E5070B-06D

S E R V I C E N O T E

E5070B ENA Series Network Analyzer, 300 kHz to 3 GHz

Change the RF signal path configuration and update firmware to 5.02 or later to improve the input damage level tolerance

Figure 15 Front View (Semirigid Cables Opt. 414 before modification)

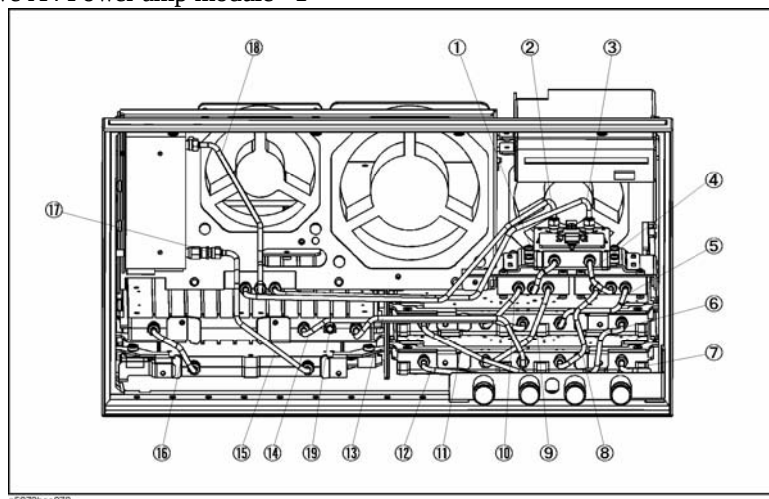
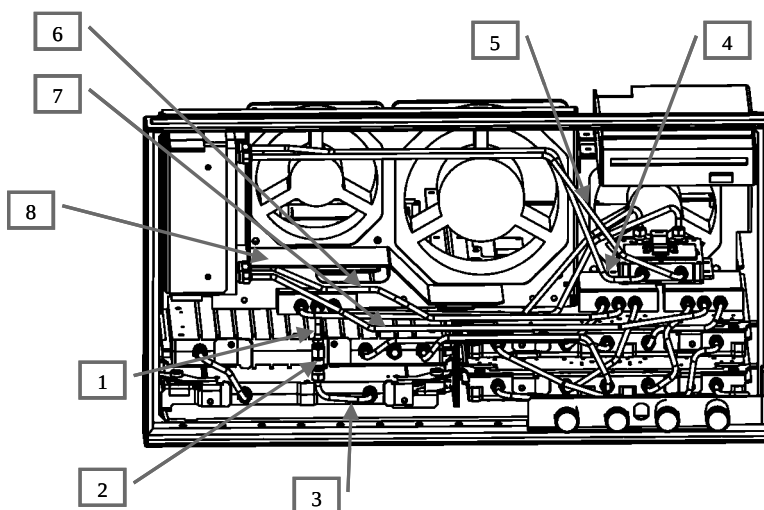
1. Remove outer cover. *1
2. Remove front panel. *1
3. Remove floppy disk drive unit. *1
4. Remove E5070-01222 (No. 8 in Figure 5) plate by 3 screws (No.9 in Figure 5)
5. Remove E5070-61685 (No 1 and No 4 in Figure 15) semi-rigid cables from A4 and A8
6. Remove E5070-61677 (No 2 in Figure 15) and E5070-61678 (No 3 in Figure 15) from A4 and A8 (source side)
7. Remove E5070-61673 (No 15 in Figure 15) semi-rigid cable from A3 and 0955-0301 (No 17 in Figure 15).
8. Remove 0955-0301 (No 17 in Figure 15) uW attenuator from A7 ATT
9. Remove E5070-61656 (No 18 in Figure 15) semi-rigid cable from A7 and A8
10. Remove defective A4 Power amp module *1

13. Install new A7 attenuator with 0515-0372 2 ea. Refer to Figure 9 for the detail.
14. Install new A4 power amp module to an original place
15. Connect A3 and 0955-0301 (removed in step 8) with E5070-61675 (No 3 in Figure 14, see below) semi-rigid cable

16. Connect 0955-0301 and A8 (source side) with E5070-61676 (No 1 in Figure 14)
17. Connect A8 (source side) and A4 with E5070-61677 and E5070-61678 that are removed in step 6

18. Connect A4 and A7 ATT with E5070-61633 (No 4 in Figure 14) semi-rigid cable
19. Connect A4 and A7 ATT with E5070-61635 (No 5 in Figure 14) semi-rigid cable

20. Connect ATT and A8 with E5070-61634 (No 6 in Figure 14) semi-rigid cable
21. Connect ATT and A8 with E5070-61636 (No 7 in Figure 14) semi-rigid cable

22. Screw E5070-01223 plate (No 8 in figure 14) instead of E5070-01222
23. To avoid the friction between new semi-rigid cables and front panel's cable clamp, remove two 1400-0611, cable clamp, from original place, then stick two new 1400-0611, cable clamp, as shown in Figure 11 lower. Then change a bending position of LCD flat cable (white one) according to Figure 11 upper
